Re: Recall campaign: Cardan unit Brevia 1100, Griso 1100

C.A.R.C. DRIVE ASSEMBLY REPLACEMENT PROCEDURE

DRAINING TRANSMISSION FLUID

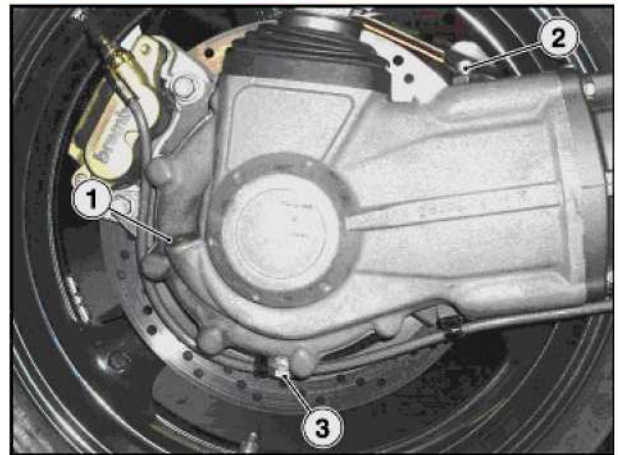
- Place a container capable of holding more than 500 cc (30.5 cu. in.) under the drain plug (3).
- Unscrew and remove the drain plug (3).
- Unscrew and remove the breather plug (2).
- Let the fluid drain into the container and allow several minutes for the fluid to drip off.
- Refit and tighten the plugs (1), (2) and (3)

Tightening torque for screw (1): 35 Nm

Tightening torque for screw (2): 30 Nm

Tightening torque for screw (3): 30 Nm

BREVA 1100 EXHAUST REMOVAL

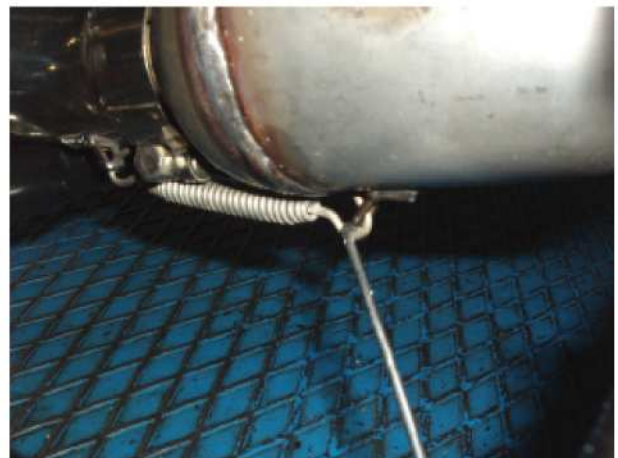
- Remove the spring attached to exhaust and central manifold using a suitable spring removal tool.

- Slacken the clamp attached to exhaust and central manifold.

- Unscrew and remove the screw securing the exhaust to the frame and collect nut, spacer and washers.

- Remove the exhaust.

Note for reassembly: Tightening torque: 10 Nm

Note for reassembly: Tightening torque: 25 Nm

C.A.R.C. DRIVE ASSEMBLY REMOVAL

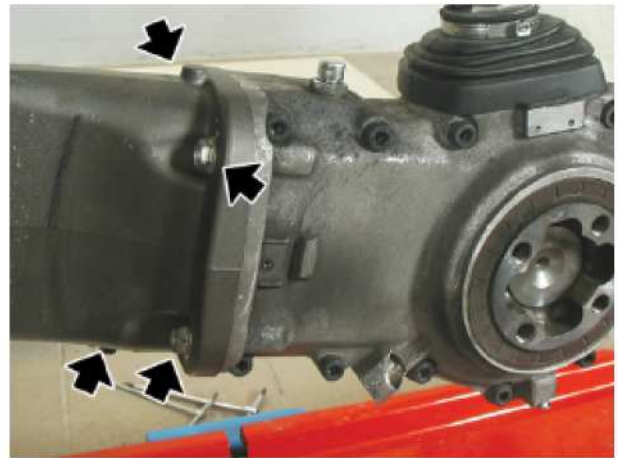
- Unscrew and remove the linkage nut.
- Remove the screw.
- Secure the linkage to the frame using a tie.

- Unscrew and remove the four screws.

- Remove the C.A.R.C. drive assembly together with the universal joint.

- Place the new dust seal supplied with the new drive assembly between wheel rim and universal joint; position the seal with the collar facing the drive assembly.
- Install the new drive assembly by reversing the removal procedure.

The C.A.R.C. drive assembly is supplied **DRY**.
Fill with the correct amount of transmission
fluid; see relevant manual for instructions.

Note for reassembly: Use 500cc (30.5 cu. in.) of transmission
fluid  TRUCK GEAR 80 W 90
